REPORT AMENDED BY CPC 6-9-88
CITY PLANNING COMMISSION

- APPLICATION:**
- A. Negative Declaration
 - B. Special Permit to establish a 170-space mobile home park on 24+ acres in the Standard Single Family-Review (R-1-R) Zone
 - C. Plan Review for a mobile home park in the R-1-R Zone
 - D. Variance to reduce the required front yard setback for a mobile home park from 25' to 15'
 - E. Variance to reduce the required interior side yard setback for a mobile home park from 15' to 5'
 - F. Variance to reduce the required rear yard setback for a mobile home park from 15' to 5'
 - G. Lot Line Adjustment to merge four lots

APPLC. NO. P88-190 **MEETING DATE** June 9, 1988 **ITEM NO.** 19

Site Plan

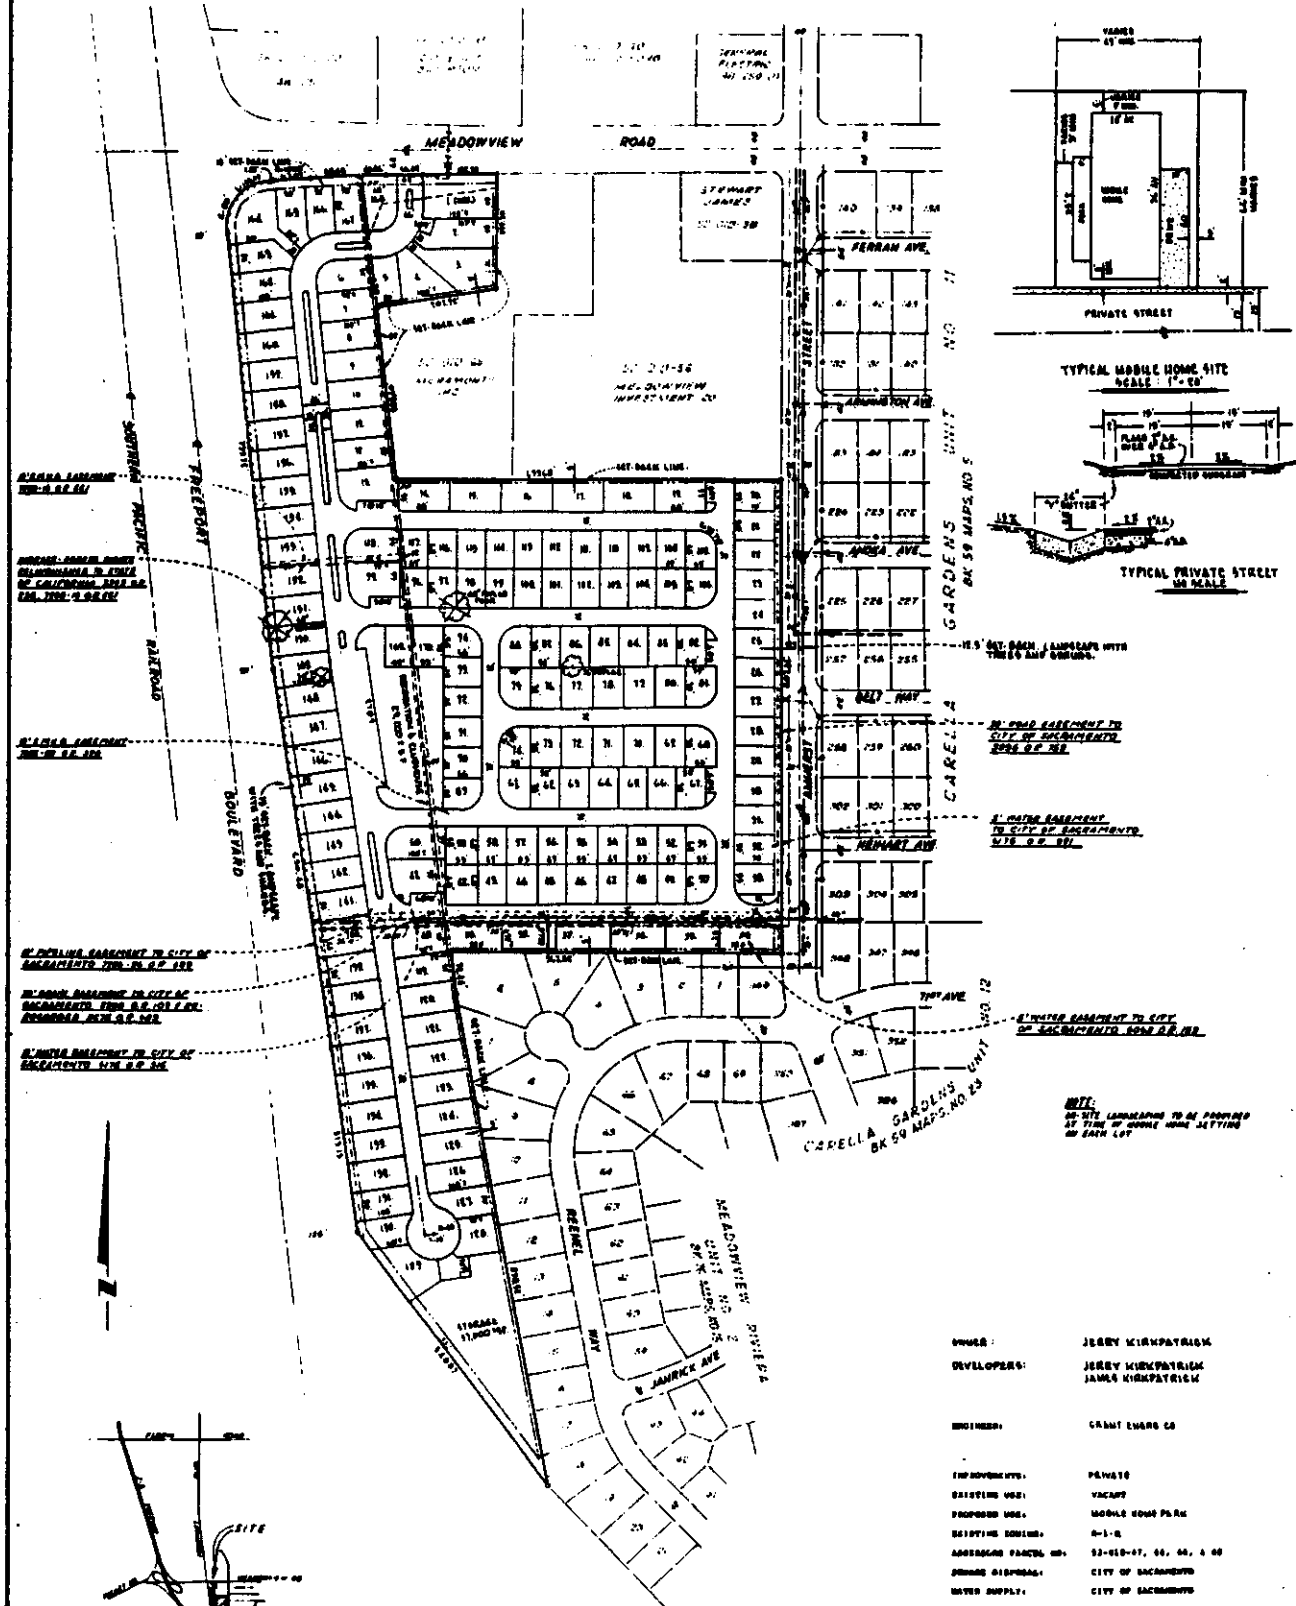
Due to the irregular shape of the subject site the applicant has requested variances to reduce the required front yard setback from 25 feet to 15 feet and the required 15 foot interior side and rear yard setbacks for mobile homes to five feet. If the required setbacks were maintained it would be difficult to provide adequate sized mobile home lots and the required driveway widths within the confines of the subject site.

Planning staff has no objections to the applicant's request to reduce the front landscaped setback as the applicant has agreed to provide a 15 foot setback on the Freeport side of the subject site. The applicant, however, has requested that the wall for the project be located on the western property line and the 15 foot setback be located on the interior of the project. Planning staff finds that having the 15 foot setback on the interior of the site would serve little purpose for mobile home park residences or the community at large. Freeport Boulevard will eventually be widened and the County portion of this road is designated a scenic highway. One of the policies of the Airport-Meadowview Community Plan is to consider designation of the City portion of Freeport Boulevard (Highway 160) as a scenic highway. A 15 foot setback landscaped with trees, lawn and shrubs in front of a solid wall will improve the appearance of the subject site and be an attractive addition to the Airport-Meadowview community. (An example, provided by the applicant, of an attractive mobile home park with 15 foot landscaped setback and solid wall is Casa de Flores Mobile Home Park at 7465 French Road). If the landscape setback was located on the interior of the site it would be hidden by the mobile homes from the private drive and the open area would be of little use to residents. Planning staff, therefore, recommends that a landscape and irrigation plan indicating a 15 foot landscaped setback on the Freeport Boulevard and Meadowview Road street sides, a 12.5 foot landscaped setback on the Amherst Street side and a solid wall behind the landscaped setback be provided for the project.

Planning staff finds that the requested five foot interior side yard and rear yard setbacks should be sufficient as long as no structures are permitted in this area and that trees, shrubs and a solid fence are provided along these property lines to screen the adjacent residential uses from the proposed use.

The applicant has proposed a 37,000± square foot open storage area for use of the mobile home park residences on the southern triangular portion of the subject site. Typically, vehicles such as RV's, campers, boats, trailers and trucks are usually stored in this area by residents. The Interstate 5 freeway is elevated adjacent to this storage area and the storage area will be able to be seen from the freeway. Planning staff has no objections to the storage area being located on this portion of the site as long as evergreen trees which canopy over the storage area are planted to screen the area from the freeway and a solid masonry wall is constructed along the east and west property lines.

Trash dumpster locations have not been indicated on the site plan. If trash dumpsters are proposed, the trash enclosure shall meet Zoning Ordinance requirements. If the applicant desires individual trash pick-up this should be coordinated with the City Solid Waste Division.

The site plan indicates 64 guest parking spaces located throughout the site. This is approximately one guest space for every two mobile homes which should be sufficient for the project. All parking lot areas should meet City shade ordinance requirements.

The applicant intends for the driveway entrance off of Amherst Street to be for emergency vehicle use only. If this entrance is proposed to have a gate it should be subject to the review and approval of the Police and Fire Departments.

1. Street sizes should be minimum 20 feet wide on each side of divider or 30 feet wide without dividers. Parking will not be permitted on the private streets unless the street width is increased to a minimum of 32 feet.
2. On-site fire hydrants are required.

Provide a solid wall adjacent to the proposed storage area.

1. Frontage improvements on Meadowview Road will be required.
2. Driveway permits for Meadowview Road and Amherst Street entrances will be required. Access on Amherst Street requires a 120 foot offset from Neihart Avenue or align driveway with Neihart Avenue.
3. Dedicate Meadowview Road to a 50 foot half section for future widening of Meadowview Road and a bike lane.
4. Left turns from the site to Meadowview Road present a public safety problem and will be prohibited. Applicant shall need to devise a method to prevent left turns to the satisfaction of the City Traffic

The applicant has indicated that he intends to delete the median strips from the private streets and widen the streets to 36 feet.

3. The applicant shall submit a landscaping, shading and irrigation plan to the Planning Director for review and approval prior to issuance of building permits/State HCD construction permits. The plan shall indicate: (a) a 15 foot setback landscaped with lawn, trees and shrubs adjacent to Meadowview Road and Freeport/Boulevard; (b) a 12.5 foot setback landscaped with lawn, trees and shrubs adjacent to Amherst Street and Freeport Boulevard ; (c) five foot interior side and rear yard setbacks landscaped with trees and shrubs; (d) screening evergreen trees (minimum 15-gallon) with a canopy adjacent to the outdoor storage area; (e) compliance with the City's Shading Ordinance for parking lot area; and (f) landscaping in the outdoor recreation area.

4. A wall and fence plan for the project shall be submitted for Planning Director review and approval prior to issuance of building permits/State HCD construction permits. A solid masonry wall shall be constructed behind the required landscaped setback on Freeport

Boulevard, Meadowview Road and Amherst Street, and surrounding the outdoor storage area on the east and west sides. A solid fence may be placed on the north side of the storage area in lieu of a solid wall. A solid fence shall be located on the remaining interior side and rear yard property lines and along the rear of the mobile home lots adjacent to the outdoor recreation area. The design and materials of the required walls and fences shall be subject to Planning Director review and approval.

5. Trash dumpster locations, if any, shall be indicated on the site plan and trash enclosures shall meet Zoning Ordinance requirements.
6. Emergency access at the Amherst Street driveway shall meet the requirements of the City Police and Fire Departments.

10. The applicant shall conduct the necessary tests for sewer, drainage and street design to the satisfaction of the City Public Works Division.
11. Fire hydrants shall be provided on the subject site and the project shall meet the street width requirements of the Fire Department.

Recreation Area Site Plan

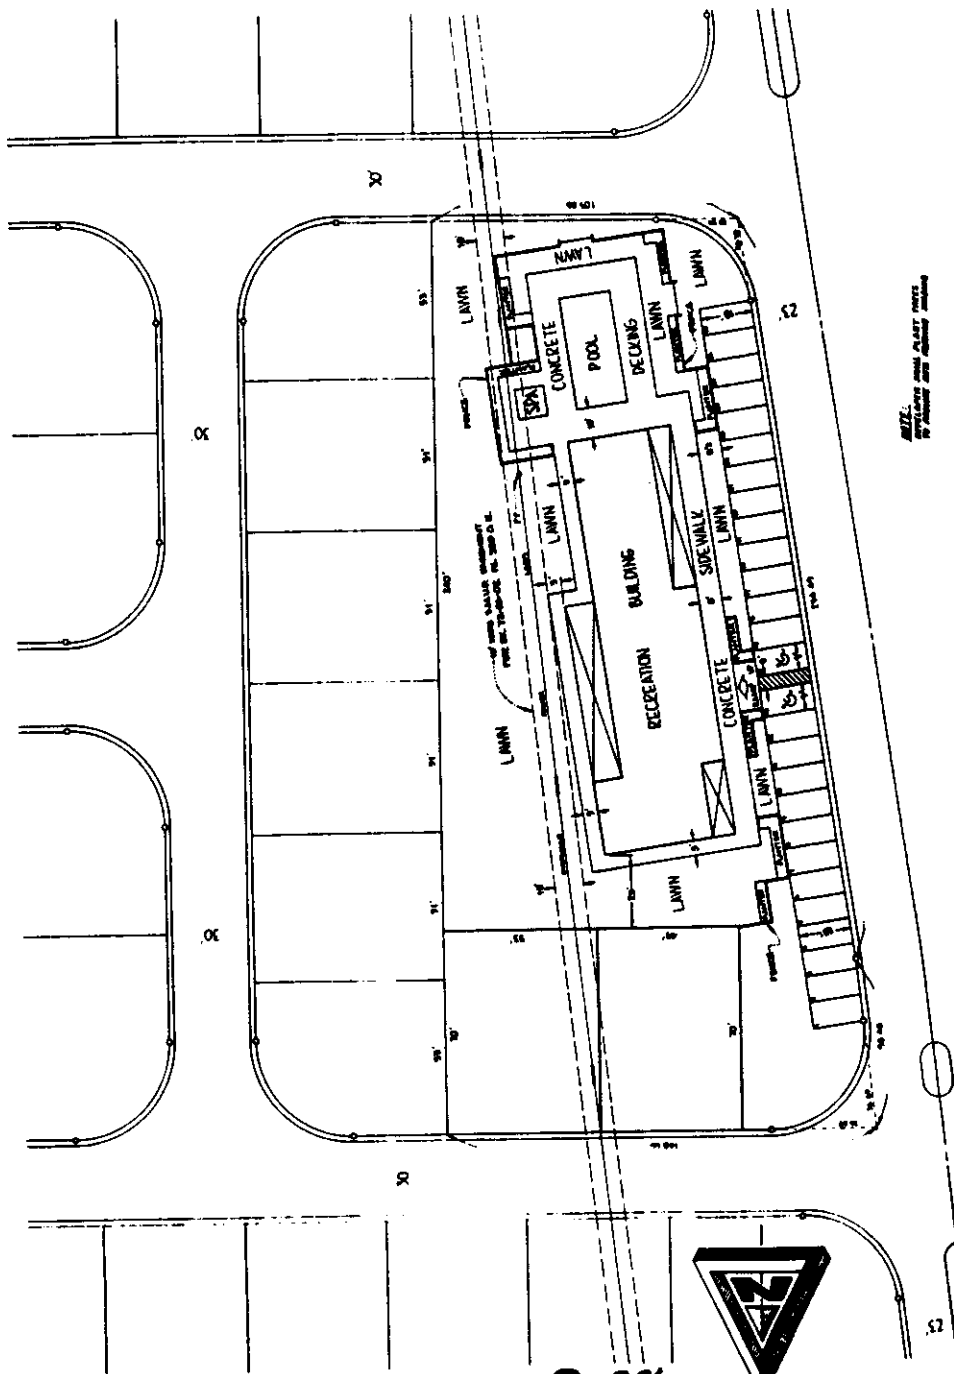
Directly behind the recreation building is an outdoor recreation area with lawn area, a swimming pool and spa. The spa is located in a portion of a 10 foot wide SMUD easement and the applicant should contact the SMUD Land Department to determine whether or not the spa can remain at this location. Seven mobile home lots back-up to the recreation area. Staff recommends that a solid fence be placed adjacent to these lots to act as a noise and visual buffer from the recreation area. Landscaping for the lawn area should be included as part of the revised landscape plan.

Recreation Building Elevations

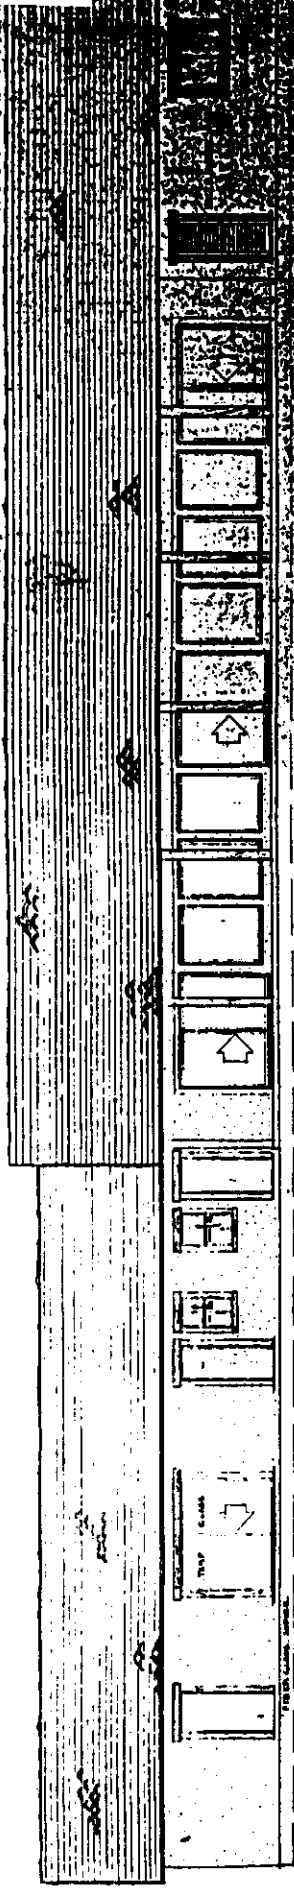
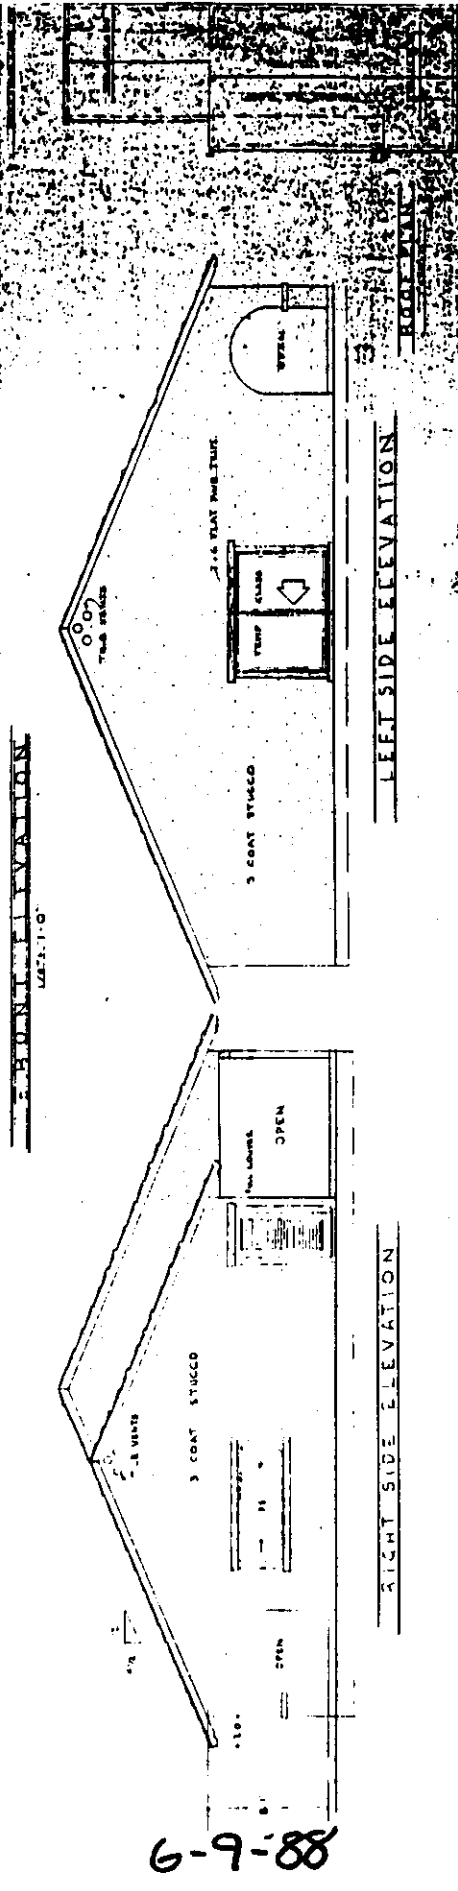
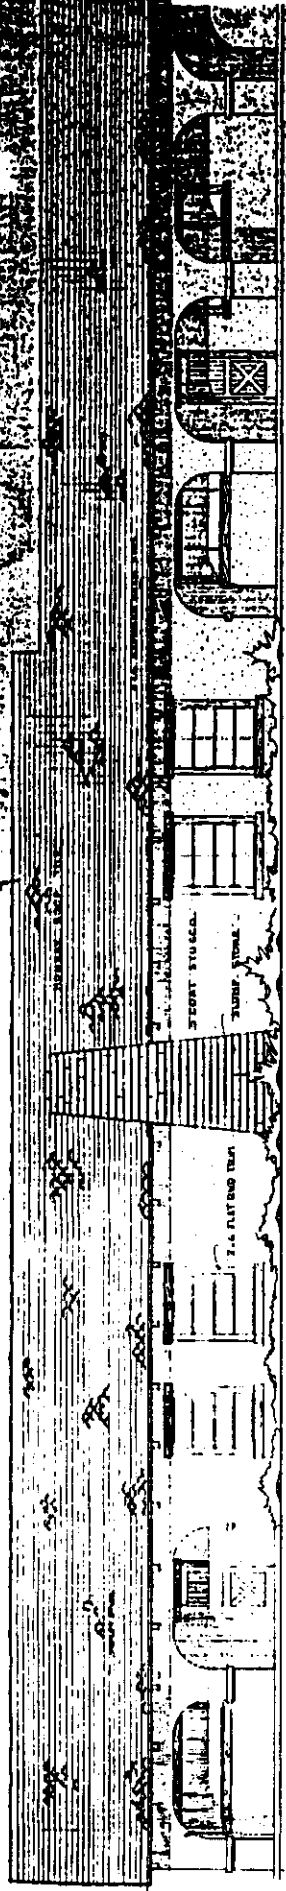
The applicant proposes to locate a one-story, 4,650+ square foot recreation building in the center of the mobile home project. The building is proposed to contain a multi-purpose room, library, kitchen, billiard room, restrooms accessible from both inside the building and the outdoor recreation area, a card room and the mobile home park offices. Exterior building materials are stucco with wood trim and a tile roof. Staff finds the proposed building elevations to be acceptable.
